PERPETUUM-EBNER

TECHNICAL BULLETIN NUMBER 7002

SUBJECT: SPEED CONTROL CAM

MODELS: PE 2018, PE 2020, PE 2038, PE 2040

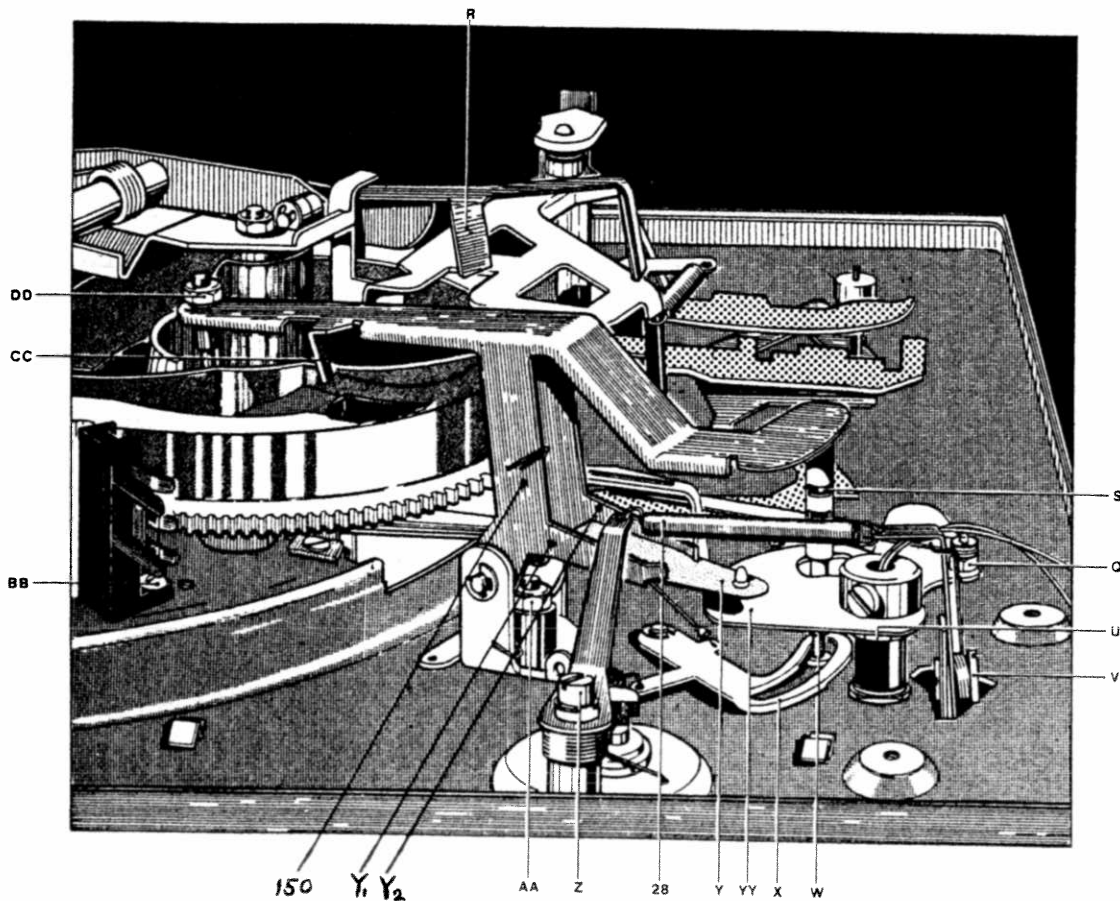
Increase the friction between the leaf spring "Y" and the tonearm locator segment "YY" by bending the two (2) arms of the feed lever assembly (150). Bend slightly both arms Y 1, Y 2, straight down the same amount so the plastic pin in the leaf spring remains parallel to the tonearm locator segment "YY".

Do not attempt to increase the friction by making the adjustment at point "DD". This will alter the height of the tonearm as well as disturb adjustments of other functions. Measure the tonearm friction (fifteen (15) to thirty-five (35) grams) after each adjustment.

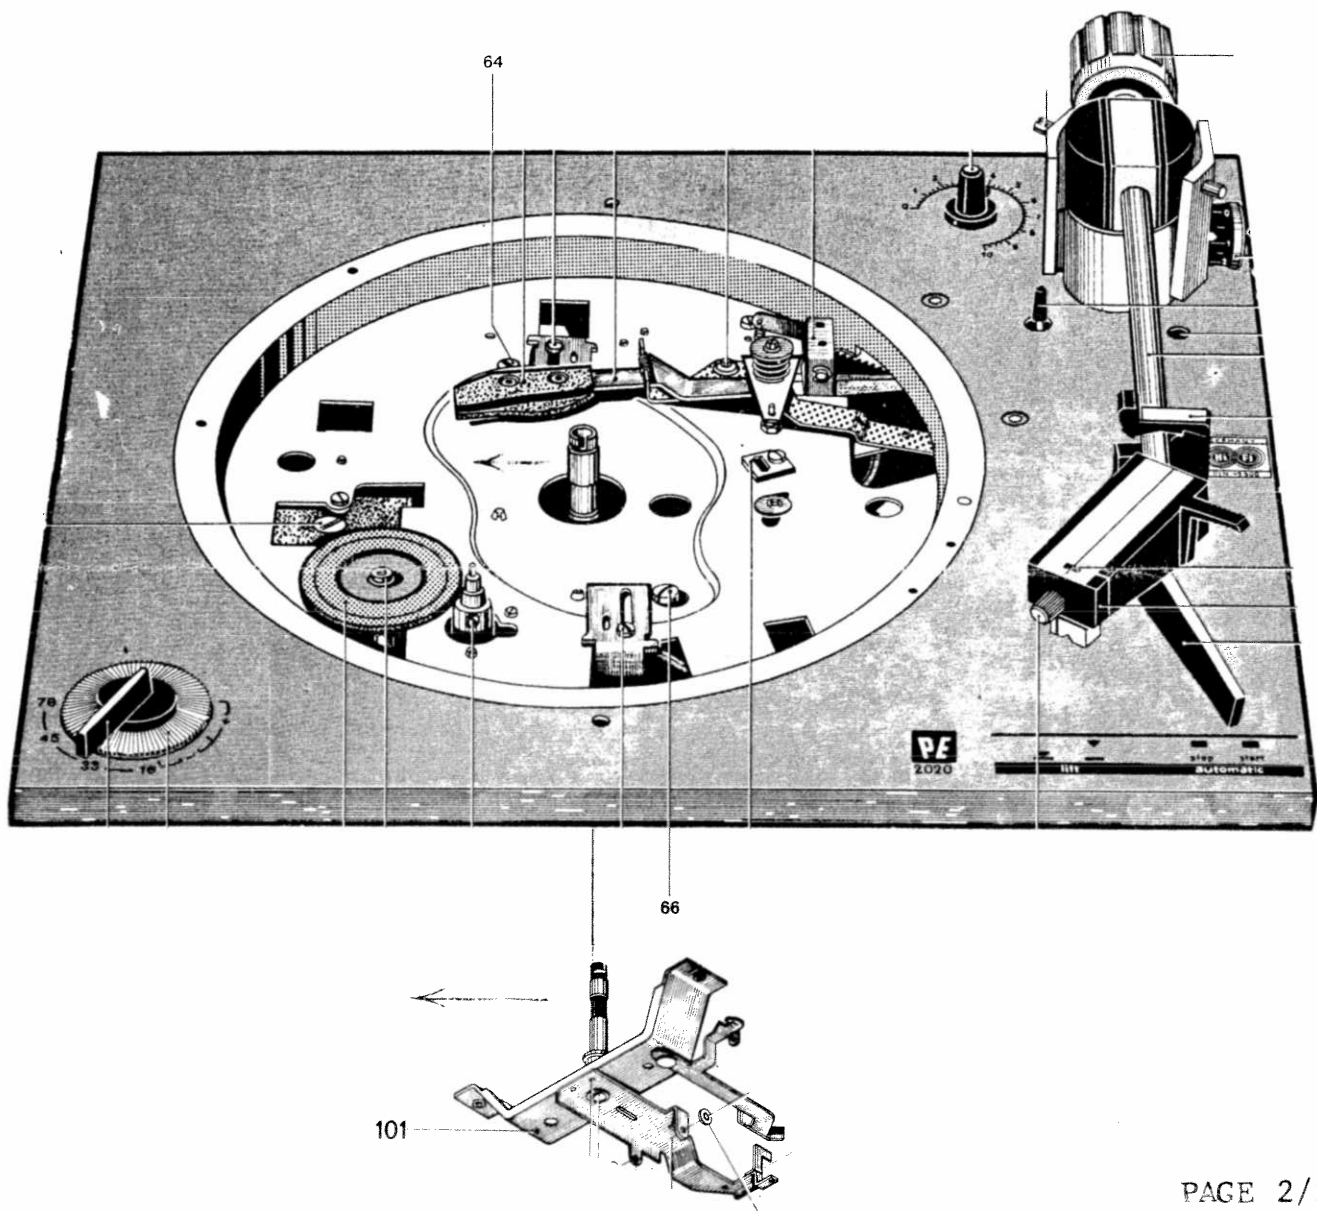
The cause of the thumping is the partial engagement of the teeth of the main cam assembly and the gear on the turntable platter once per revolution.

The complete bearing bracket assembly (item 101) must be shifted to the left of the turntable chassis. The bearing bracket assembly is secured to the chassis via two screws (items 64 and 66). Sufficient play should exist in the chassis holes to accomplish the necessary repositioning. If there is not, the two screws should be removed and the holes enlarged slightly with a small round file.

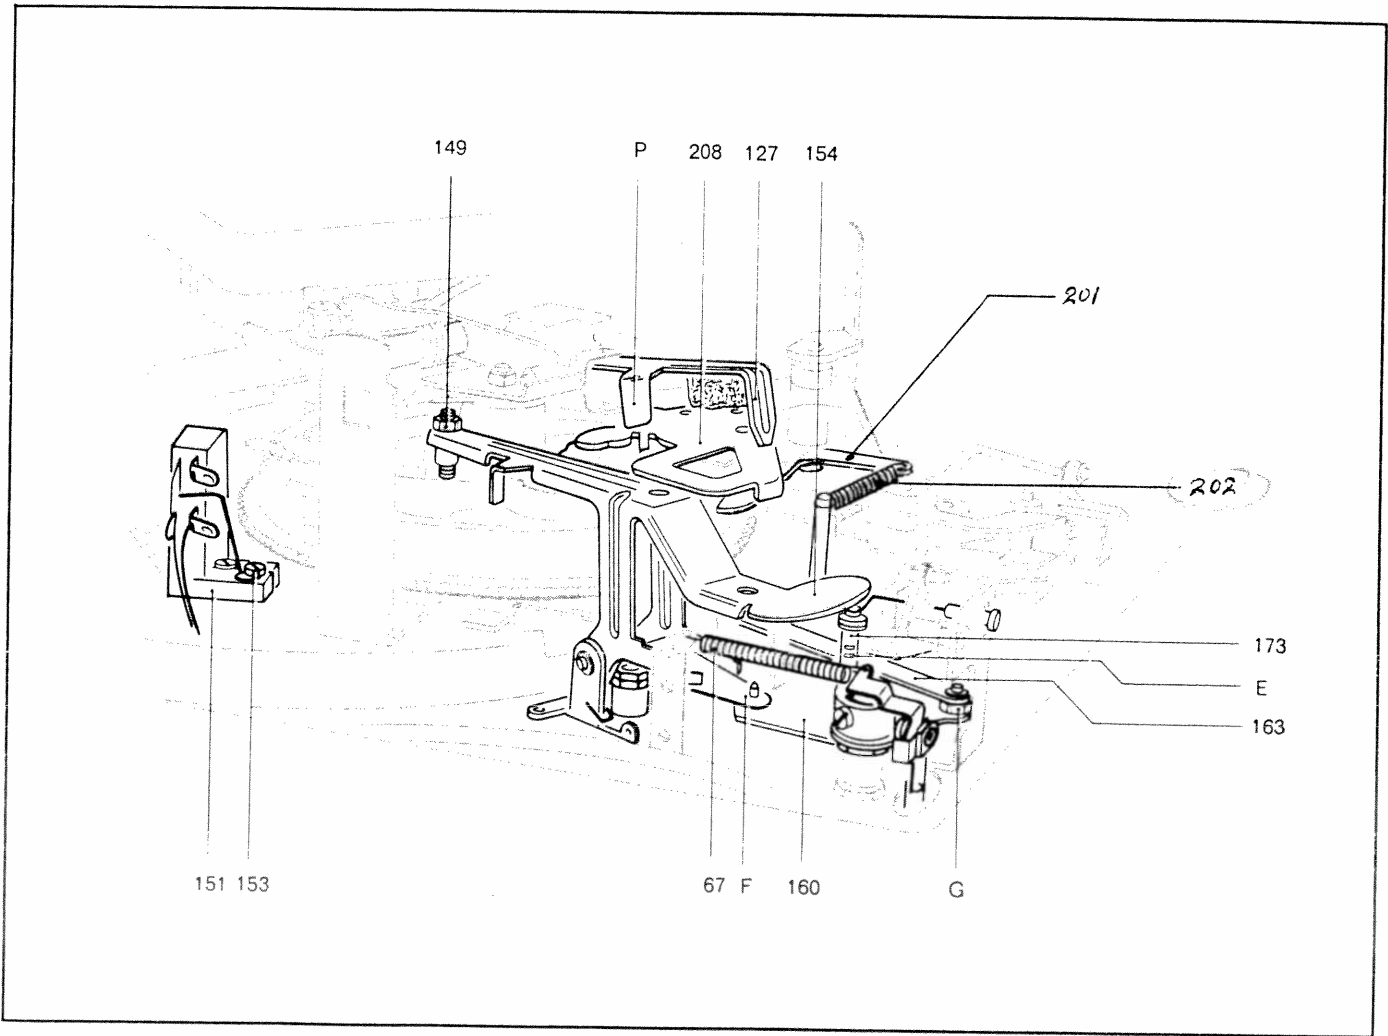
The lock pawl (201) plastic tip secures the main cam after completion of each cycle. However, after the "stop" operation the cam cycle may be incomplete. A slight pressure on the lock pawl, where the spring connects, will produce a "click" indicating the cam has not fully completed the cycle. Remove the lock pawl spring (202) and cut off approximately 1/3 of the coils (approximately 7 coils). Bend the last coil flat to form a hook and replace on the lock pawl and fixed post. Follow operational sequences a, b and c as described in PE Technical Bulletin No. 7007 and check for thumping once per revolution.

FIGURE 1

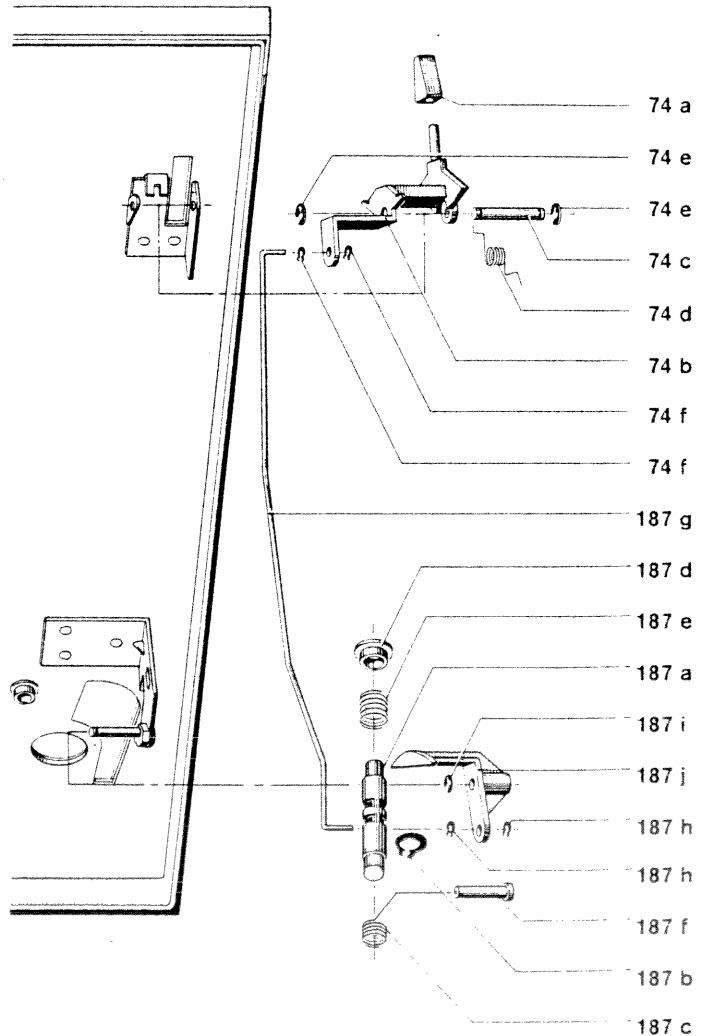
1. Remove the feed lever (item 150) Refer to figure 1
2. Disconnect and remove the trip link (item 186)

3. Remove the tonearm locator segment (item 184)
4. Remove the cueing sleeve subassembly (item 163)
5. Remove the lock nut (item 162)
6. Remove Hex Nut (item 24)

7. Release the tonearm wiring harness by bending the tiedown tabs. It is not necessary to unsolder the tonearm wires from the muting switch.
8. The tonearm and console assembly may be removed from the chassis and laid aside exposing the lift rod (item 57).

9. Disconnect the draw spring (item 58) and remove the lift rod and cylinder fitted to the chassis with a pipe cleaner moisten with alcohol or lighter fluid.

10. Apply a small quantity of silicon grease evenly to the notched shaft of the lift rod. Replace the lift rod and draw spring.
11. Fit a counterweight and weighted cartridge slide to the tonearm. Zero balance the tonearm and apply approximately 2 grams stylus force by holding the tonearm and console assembly in place on the chassis by hand.

FIGURE 2

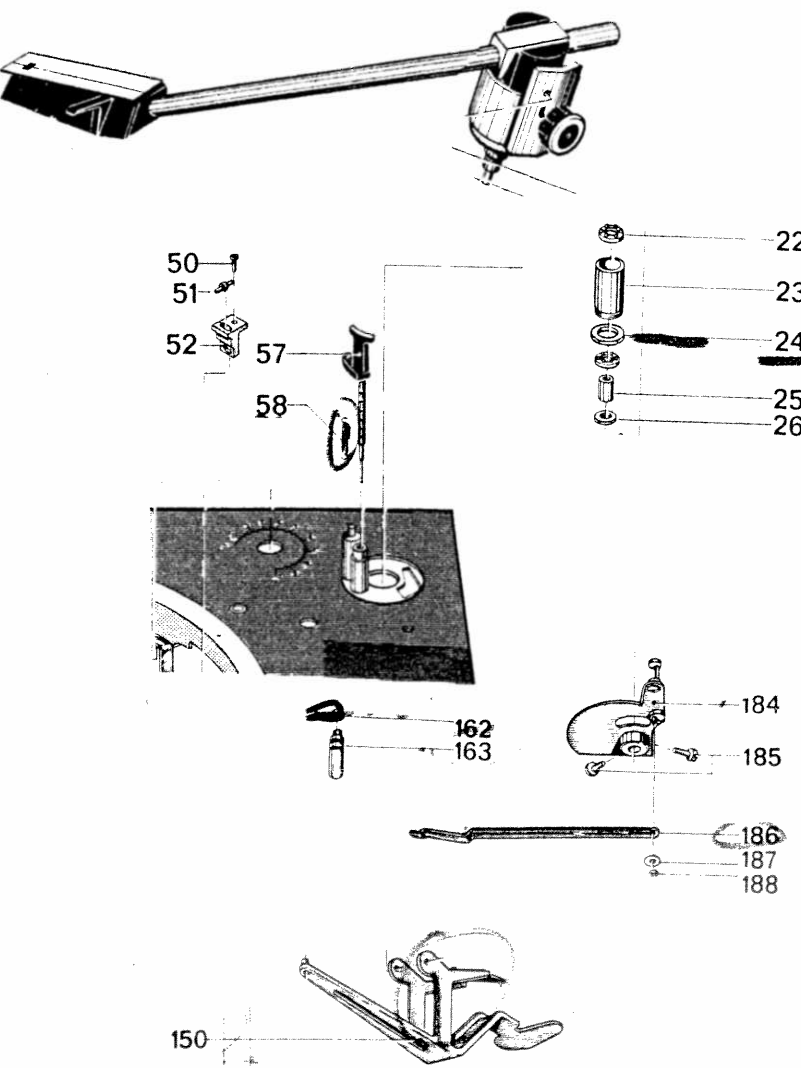
1. Follow steps 1 and 2 above for model PE-2018
2. Remove "c" clip (item 74e) refer to figure 2 and slide the pivot shaft (item 74c) out releasing the spring and cam (item 74d and 74b).
3. Move the cueing lever (item 187q) to position the lift cam (item 187j) so the cueing sleeve subassembly, spring and step washer (item 187a,b,c,d,e) may be lifted off.
4. Follow steps 5 through 13 for model PE-2018. Refer to Figure 1.
